Town of Orange Park
Planning and Zoning Board Meeting
Thursday, November 12, 2026
6:00 PM
Agenda

Item Title: Site Plan Review Application SP-3-2026 for 1413 Kingsley Avenue (Kingsley Chiropractic Expansion)

RE: Kingsley Chiropractic – 1413 Kingsley Ave
Civil Plan Review – SP-3-2026

C-3.0

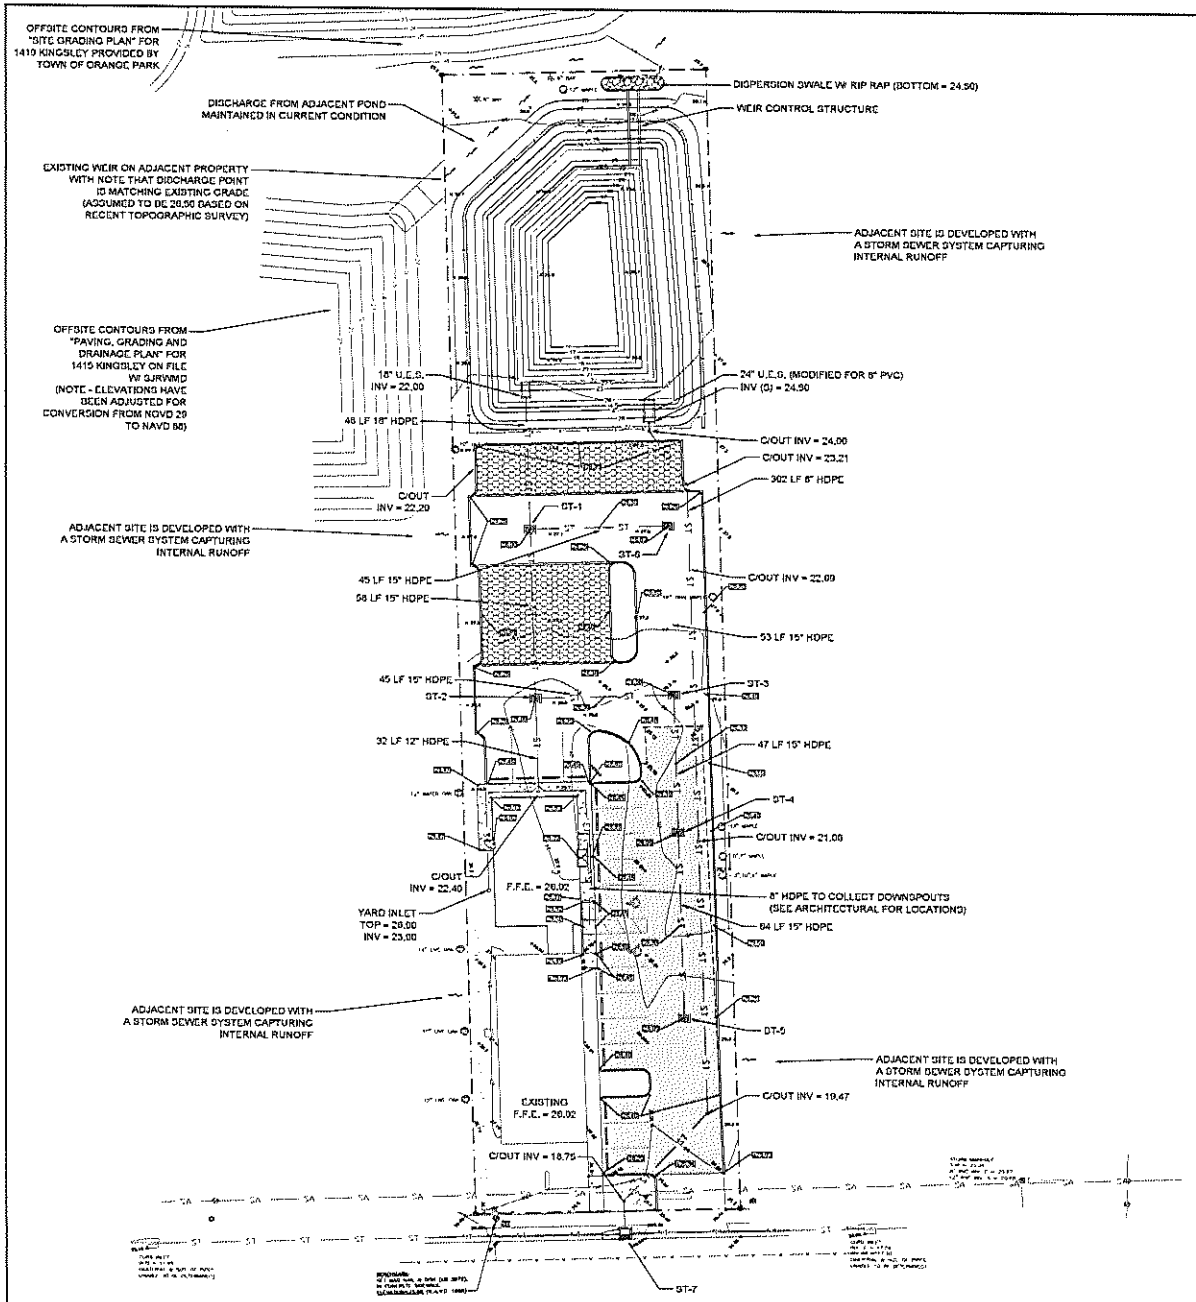
- If a two-inch water service is required for the building expansion, please re-submit utility plans. Note that this connection should be made from the proposed 6-inch tap for the proposed fire hydrant. A 2-inch RPZ backflow device will also be required.
- Prior to commencement of construction, please provide a copy of any state or federal permits. Provide updated plans if applicable.
- Plans have been approved with the understanding that the developer / contractor is responsible for any damage done to the existing water main on Kingsley Avenue as a result of the proposed 6-inch tap.
- Prior to construction, an FDOT approved maintenance of traffic (MOT) plan must be submitted to the Town for all work to be done in the Kingsley Avenue right of way.
- A silt fence inspection is required prior to any clearing or grading operations.
